~~Base document for ALKS for low speed application prepared by co-chairs~~

Proposal for Technical Requirements for an Automated Lane Keeping System (based on ACSF-23-02r4)

Schematics of the Sensing System of the ALKS

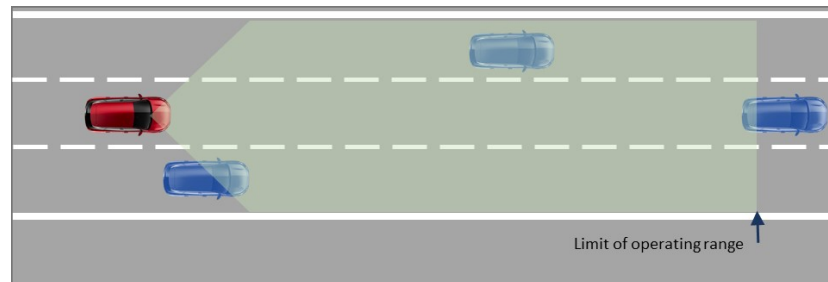
The ALKS vehicle shall be equipped with a sensing system such that it can determine the driving environment (e.g. road geometry ahead, lane markings) and the traffic dynamics across its own traffic lane, the traffic lane immediately to its left and to its right up to the limit of the operating range.
